**Ultrasonic Phased Array
Assessment of the Interference
Fit and Leak Path of the
North Anna Unit 2 Control Rod
Drive Mechanism Nozzle 63 with
Destructive Validation**

Manuscript Completed: January 2012
Date Published:

Pacific Northwest National Laboratory
P.O. Box 999
Richland, WA 99352

G. Oberson, NRC Project Manager

Figure 1.1 CRDM J-groove Weld Schematic

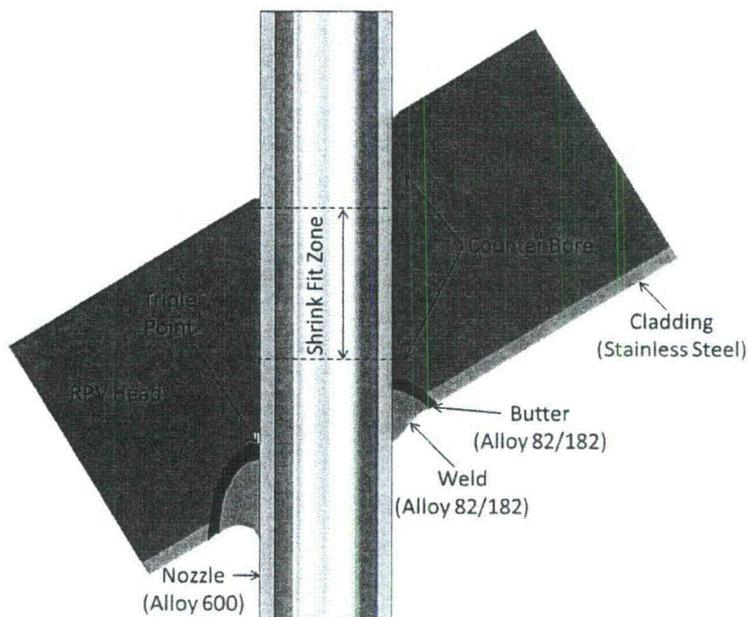
Comment [PG03]: Why doesn't the shrink fit go down to the top of the J-groove weld?

Figure 3.2 5.0-MHz Phased Array Probe

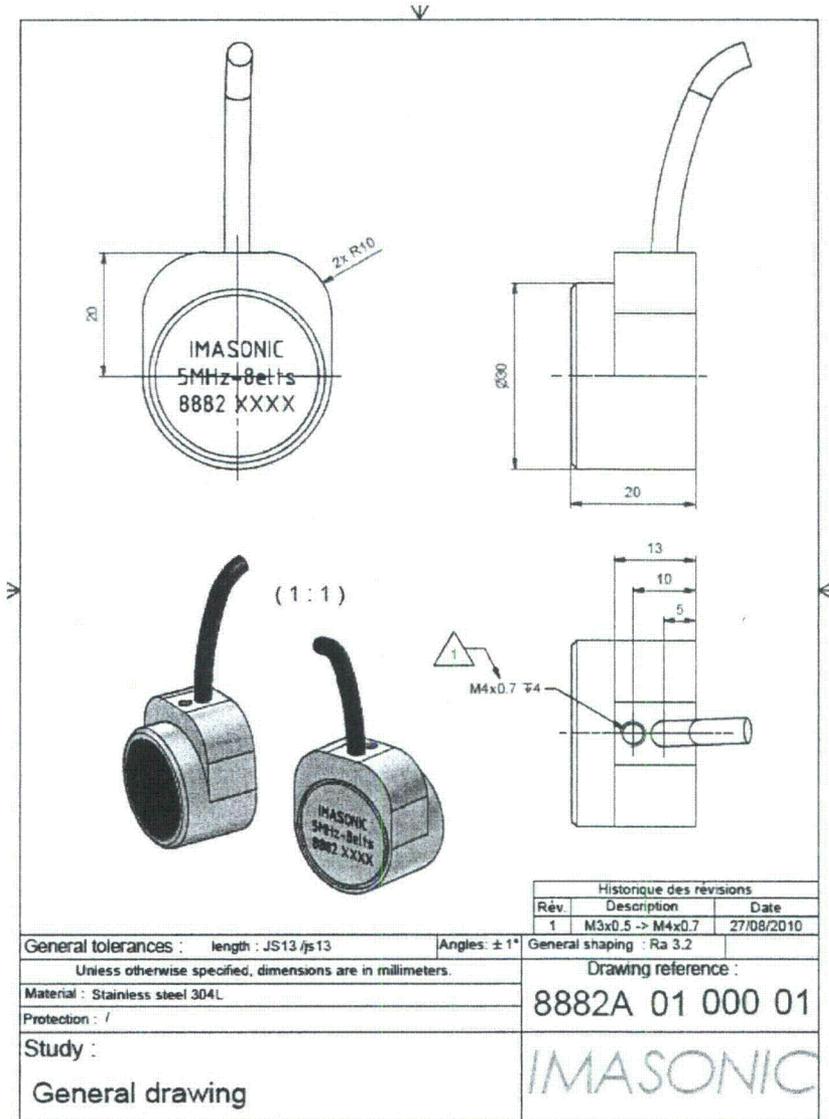
Comment [PG04]: Do you have (or need) permission to use this figure?

Figure 3.4 Law Formation and Sound Field Simulation for a Depth Focus of 15 mm

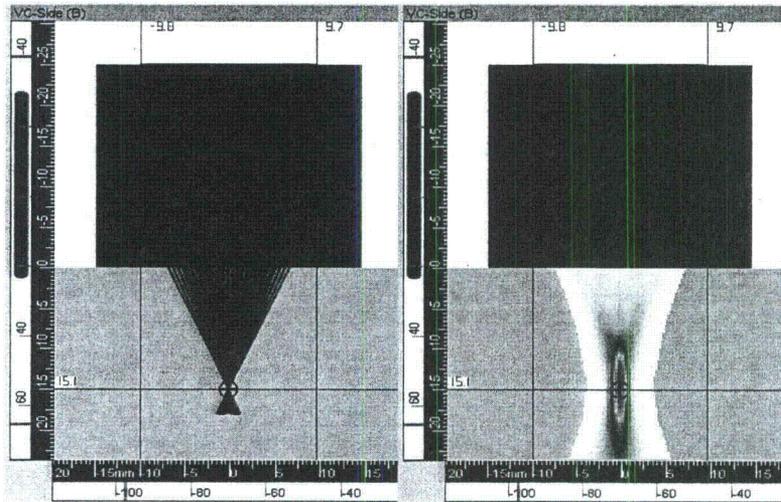
Comment [PG05]: Where is probe in this figure?

Figure 3.5 C-Scan View at a Depth Focus of 15 mm. Top: -6 dB spot size. Bottom: -3 dB spot size.

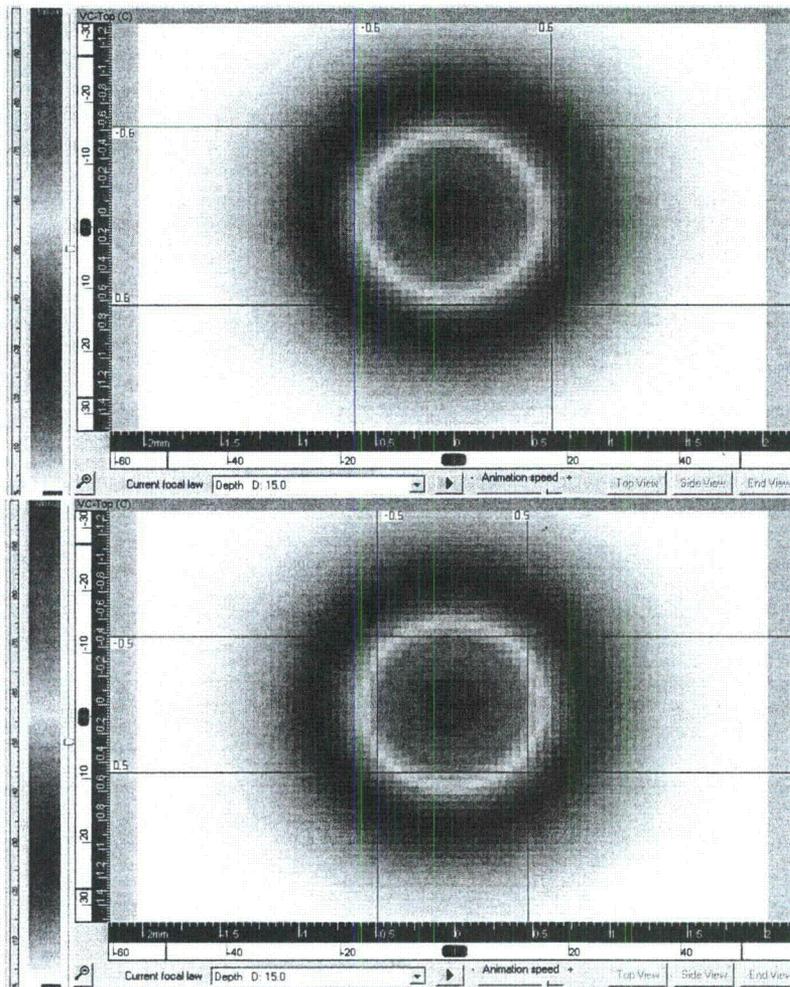
Comment [PG06]: What is significance of red and blue lines?

Figure 3.8 Scanning Setup/Orientation Schematic

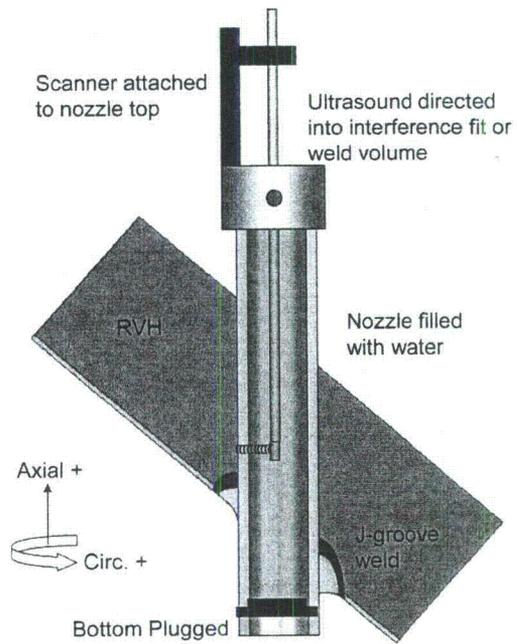
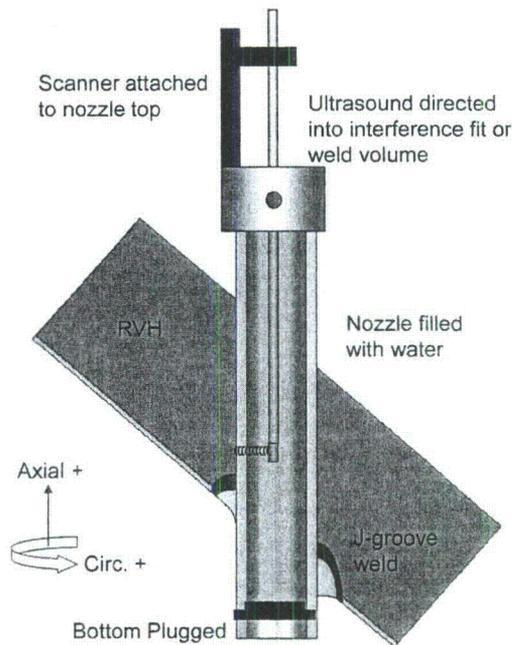
Comment [PG07]: Same as figure 5.3

Comment [PG024]: You have already used this image (Fig. 3.8). Do not repeat it. Reference previous figure if necessary.

Figure 3.9 Scanner System on Nozzle 63 in the Custom Glove Bag

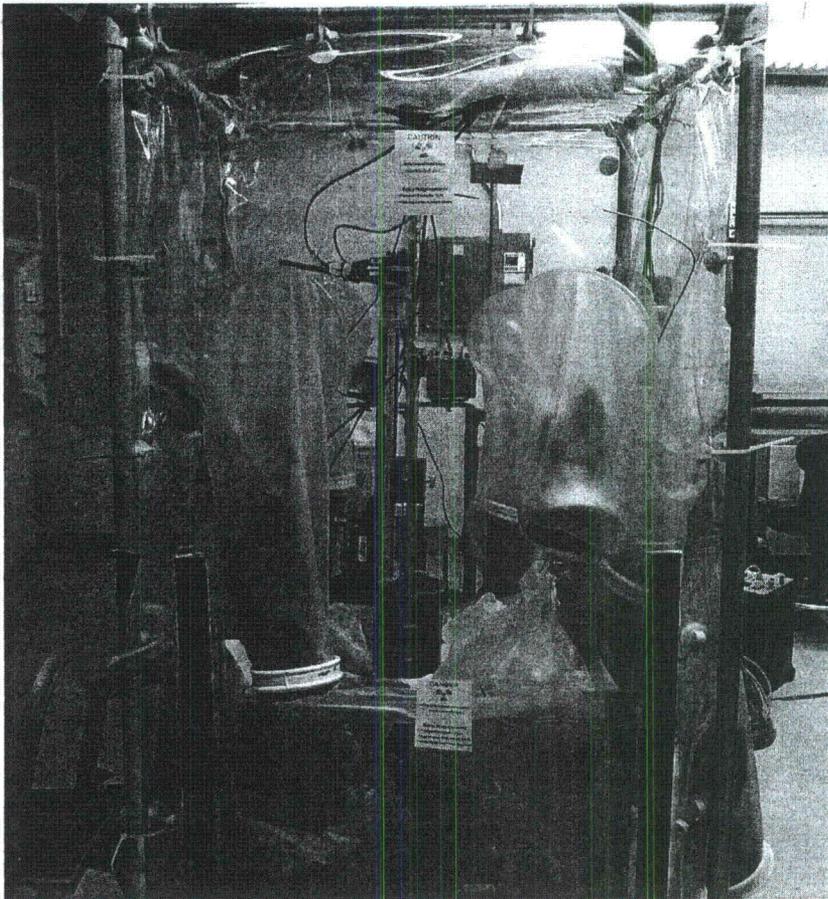
Comment [PG08]: Same as figure 5.2.

Comment [PG023]: Same as Figure 3.9

Figure 4.3 Boric Acid Application

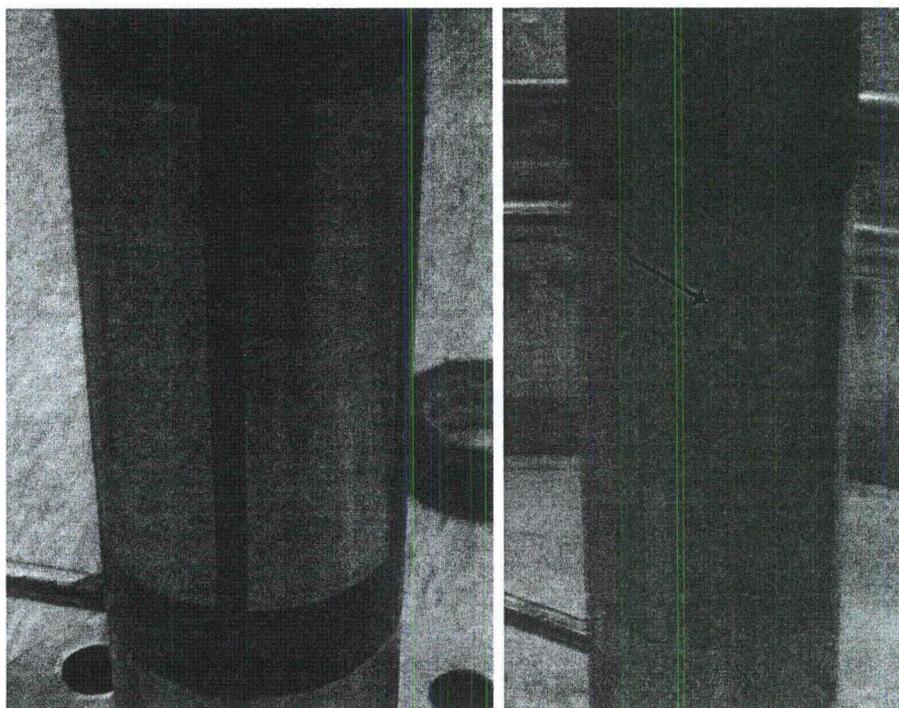
Comment [PG09]: State that in the image on the left the blue tape indicates masked regions and that the arrow on the right indicates the path where the boric acid was scraped off.

Figure 4.9 Tube Shrinkage Measurements

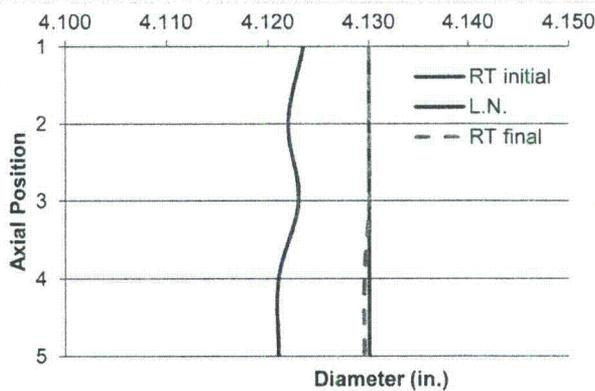
Comment [PG011]: This extended discussion isn't necessary.

Figure 4.13 Top View, Plan View, or C-scan Ultrasonic Image of the Upper Interference Fit Region Containing Calibration Notches in the Alloy 600 Tube

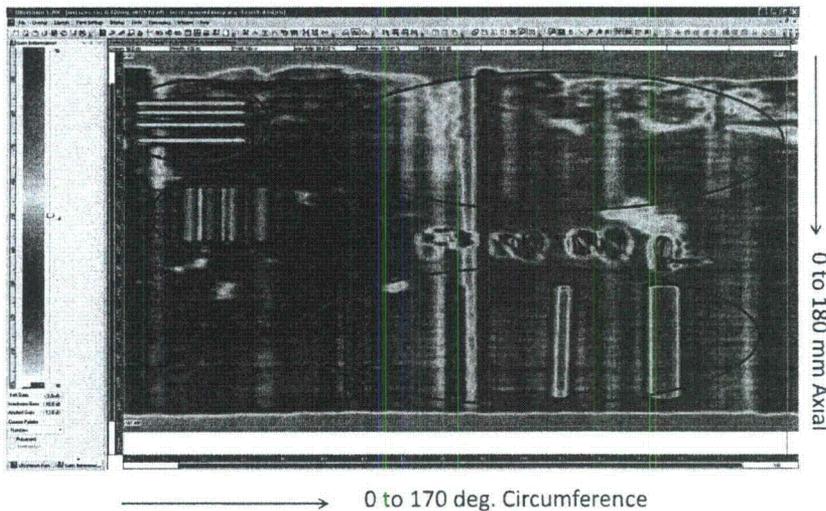
Comment [PGO13]: Please state in the figure caption what is circled

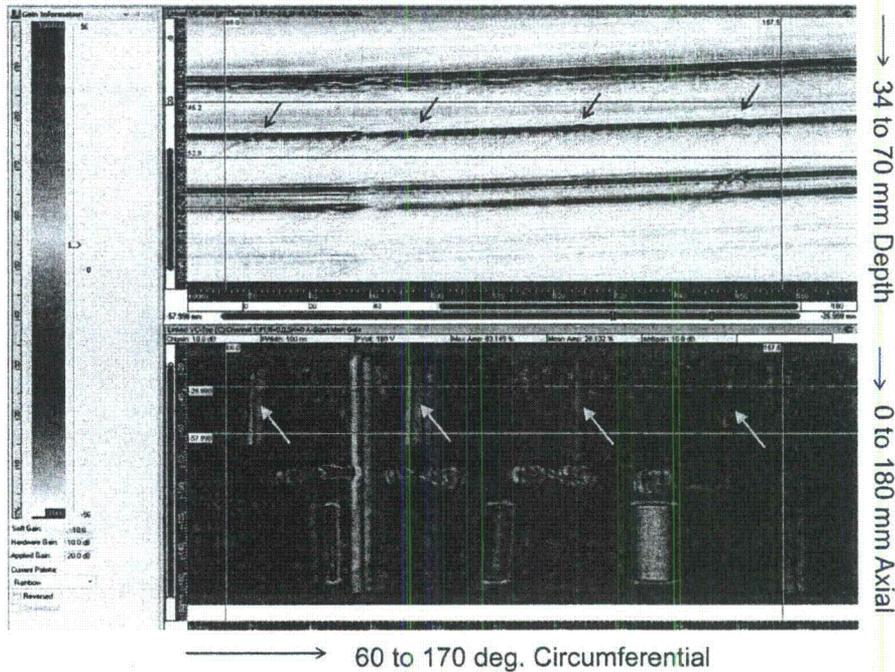
Comment [PGO14]: State what arrows are pointing to in bottom image.

Figure 4.19 C-scan Plan View of the Depth Notches in Carbon Steel, on the Upper Right.
 This image was acquired from the first ultrasonic echo.

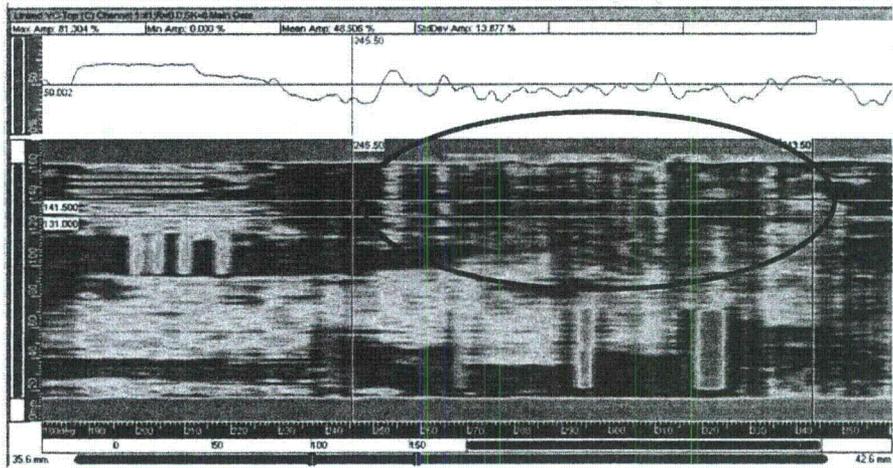
Comment [PG016]: Say what is circled.

Figure 4.20 C-scan Plan View of the Depth Notches in Carbon Steel, on the Upper Right.
 This image was acquired from the second ultrasonic echo.

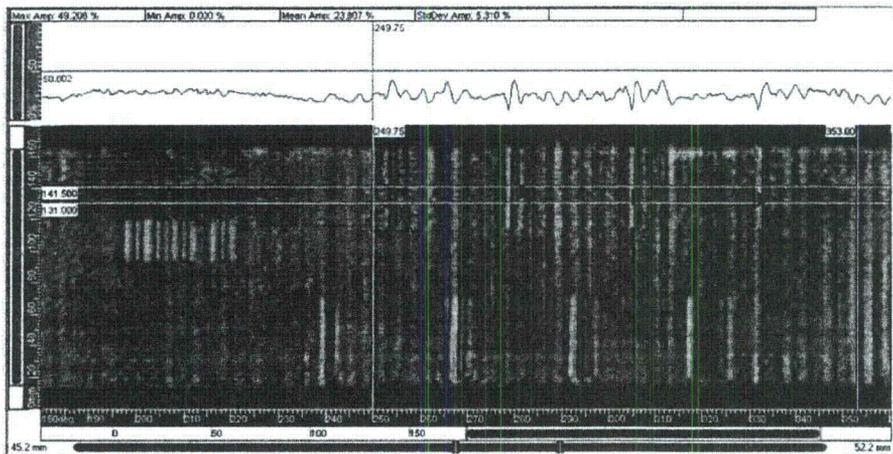
Comment [PG017]: Say what arrows are pointing to.

Figure 4.21 C-scan Plan View of the Width Notches in Carbon Steel, on the Bottom. This image was acquired from the second ultrasonic echo.

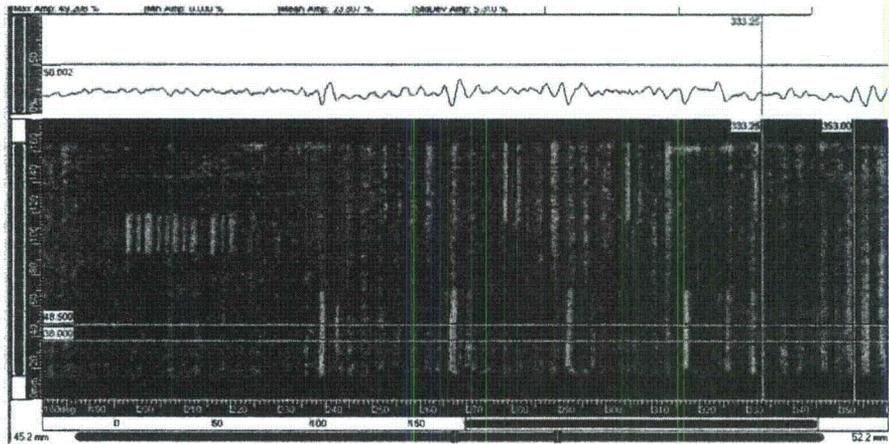
Comment [PG018]: Say what arrows are pointing to.

Figure 4.22 C-scan Plan View of the Boric Acid Deposits in the Lower Interference Fit Region. The horizontal axis represents the circumferential range of 60–240 degrees. **This image is from the first ultrasonic echo.**

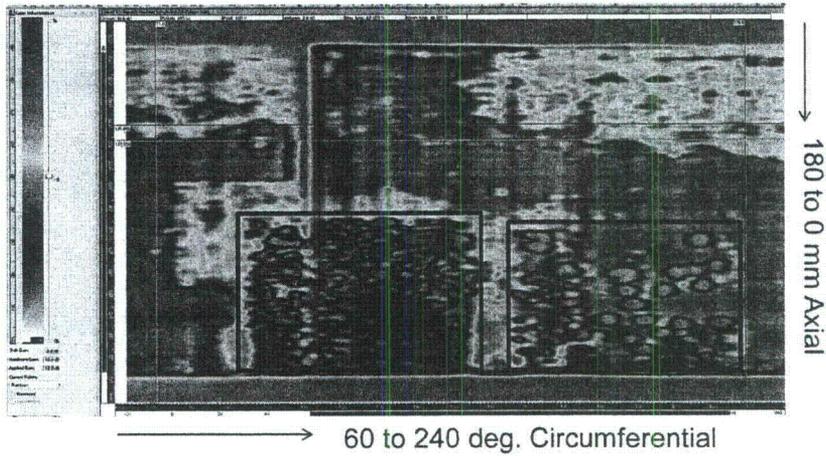
Comment [PGO19]: Say what is boxed.

Figure 4.23 C-scan Plan View of the Boric Acid Deposits in the Lower Interference Fit Region. The horizontal axis represents the circumferential range of 240–60 degrees. **This image is from the first ultrasonic echo.**

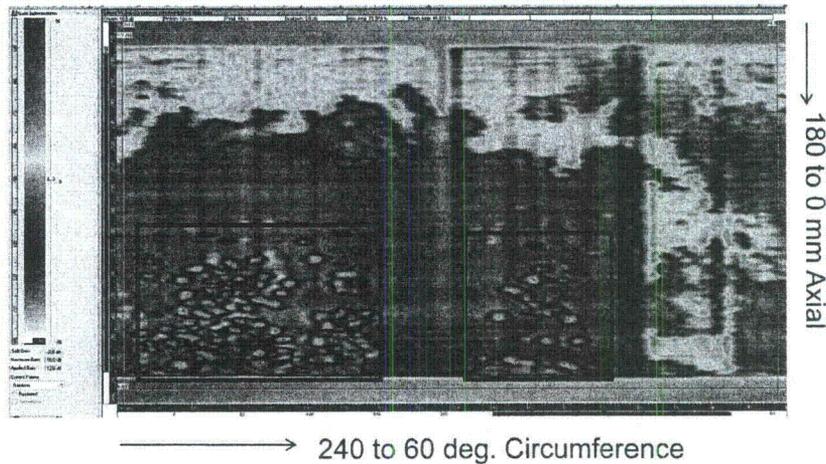
Comment [PGO20]: Say what is boxed.

Figure 5.1 Calibration Data on the Blank Nozzle Piece Before (left) and After (right) Transport to RPL/33. The horizontal axis represents 150 degrees of circumference and the vertical axis represents 50 mm (1.97 in.) in the axial direction in each image.

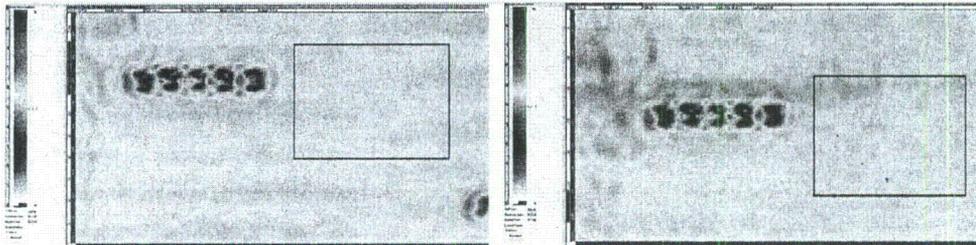
Comment [PGO22]: Don't need all the description and figure. Just can say that the scanner functionality was validated after moving.

Figure 5.4 Alloy 600 Tube ID Response Before (left) and After (right) Centering the Scanner on the Nozzle. The horizontal axis represents approximately 180 degree and the vertical axis 20 mm (0.79 in.).

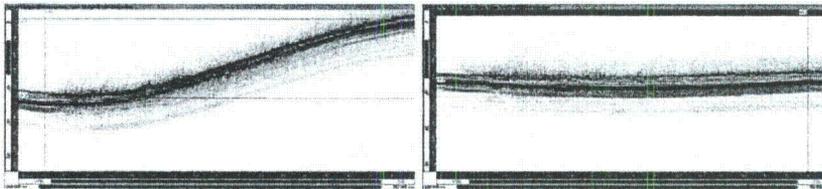
Comment [PGO26]: You don't need this figure. Just say that the probe was centered.

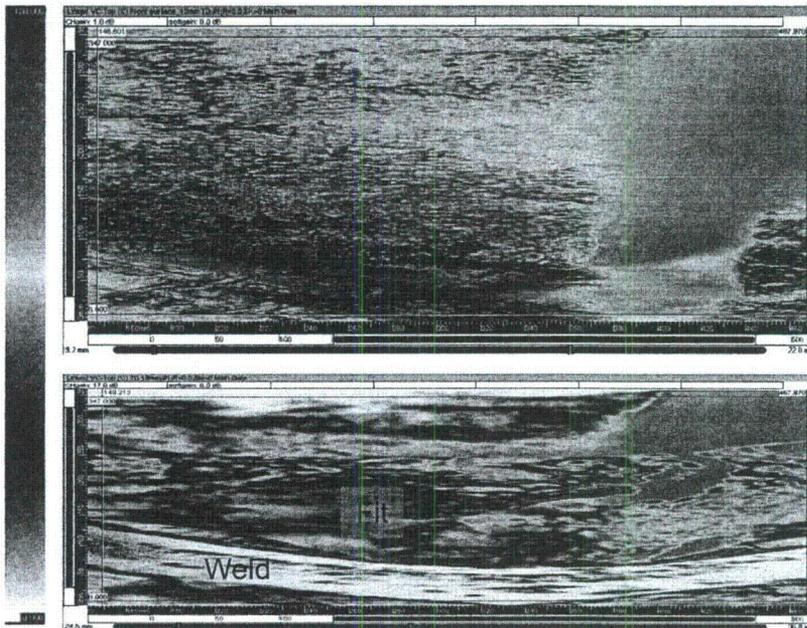
Comment [PG027]: Remove figure

Figure 5.6 PA Ultrasonic Data from Nozzle 63 Acquired After Cleaning the Probe Face. The front surface or nozzle ID echo is on the top and the interference fit echo on the bottom. The horizontal axis represents the 86 to 274 degree area and the vertical axis represents 360 mm (14.17 in.)

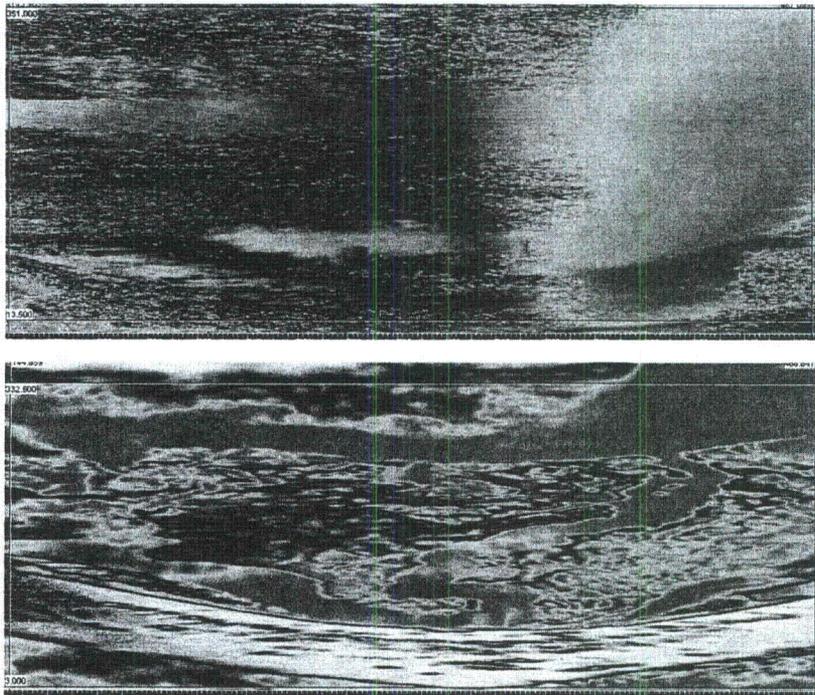
Comment [PG028]: Remove figure.

Figure 5.7 Bubbles are Detected on the ID of the Nozzle, some of which are Indicated by Arrows. The vertical axis represents 25 mm (0.98 in.) and the horizontal axis represents 190 degrees.

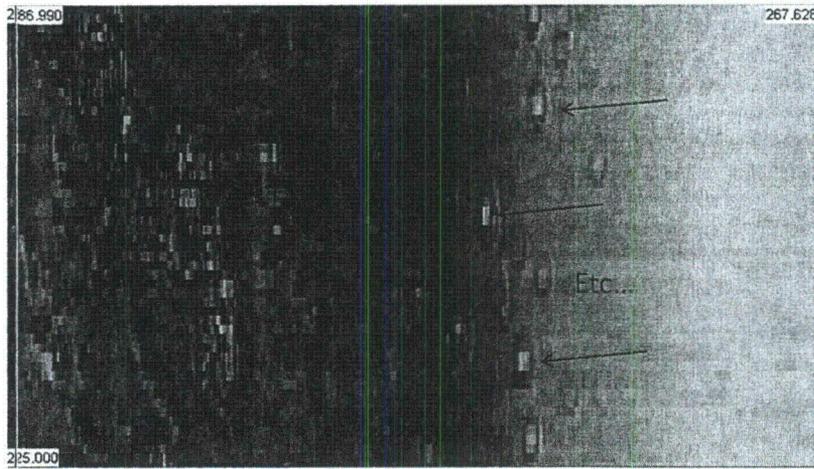
Comment [PGO29]: Remove figure.

Figure 5.8 Brush Used to Remove Surface Bubbles (top); Brushing in Progress (bottom)

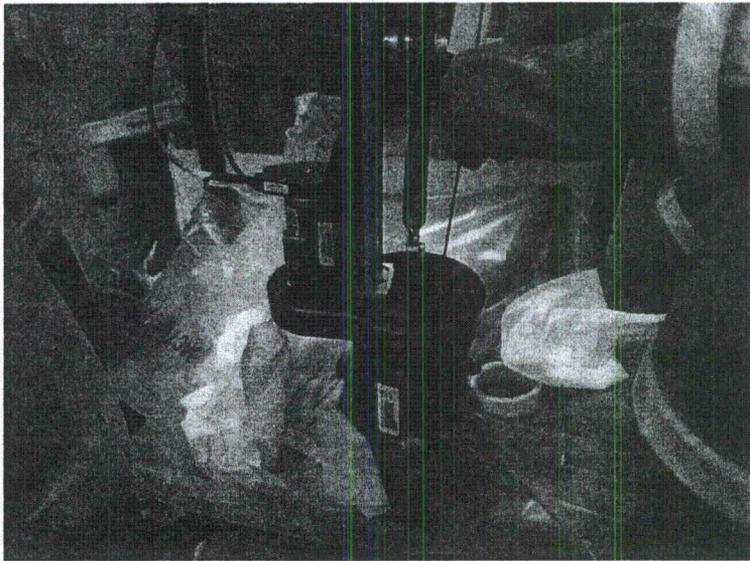
Comment [PG030]: Remove figure.
